Access Compliance Report

Public Rights-of-Way

(Curb Ramps)

Intersection ID: 43843	Main Street: DELUCA_DR	Cross Street: ROTHMAN_LN	Location:	W
ADA ID: 24E7C7BF0B55	Ramp Type: PerpDiag	Initial Pass/Fail: Fail	Overall Compliance: No	Severity Score: 8.75
Codes/Mitigation Info/Possible Solution		Field Measurements/Component Compliance

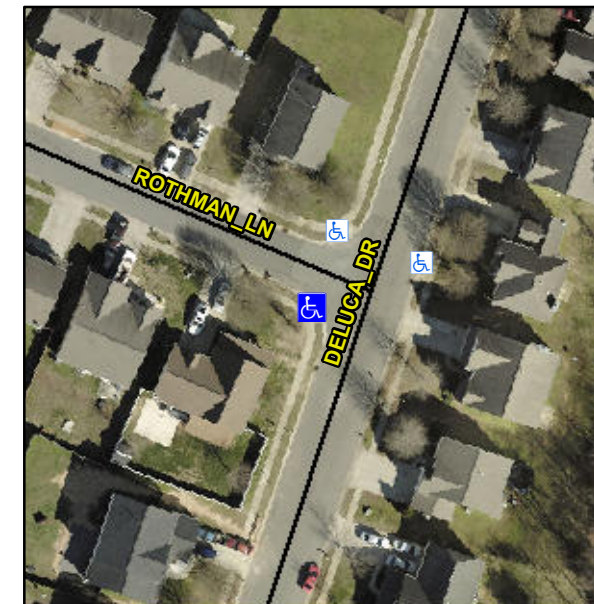
Not Found, R304.5.1

Compliance	Description	Data	Compliance	Description	Data
N/A	Ramp Length (in)	48.5	Yes	Ramp Slope (%)	6.9
No	Ramp Width (in)	47.5	Yes	Ramp XSlope (%)	1.4
N/A	Flare Type LT	N/A	N/A	Flare Type RT	N/A
N/A	Flare Slope LT (%)	N/A	N/A	Flare Slope RT (%)	N/A
N/A	Flare Traversable LT?	N/A	N/A	Flare Traversable RT?	N/A
N/A	Landing Length (in)	N/A	N/A	DWS Provided?	N/A
N/A	Landing Width (in)	N/A	N/A	DWS Contrast?	N/A
N/A	Landing Slope (%)	N/A	N/A	DWS Length (in)	N/A
N/A	Landing X Slope (%)	N/A	N/A	DWS Full Width?	N/A
N/A	Landing Curb? (Y/N)	N/A	N/A	DWS Offset (in)	N/A
N/A	Shared Landing?	N/A			
N/A	Gutter Ponding?	N/A	N/A	Gutter Slope (%)	N/A
N/A	Gutter Lip Ht (in)	N/A	N/A	Gutter X Slope (%)	N/A
N/A	Painted X Walk1?	No	N/A	Painted X Walk2?	No
	X Walk 1 Direction	To S		X Walk 2 Direction	To N
N/A	X Walk 1 Width (in)	N/A	N/A	X Walk 2 Width (in)	N/A
	X Walk 1 Slope (%)	3.8		X Walk 2 Slope (%)	2.8
	X Walk 1 X Slope (%)	1.5		X Walk 2 X Slope (%)	0.7

Remove & Replace Curb Ramp With Two New Directional Ramps or Equivalent.
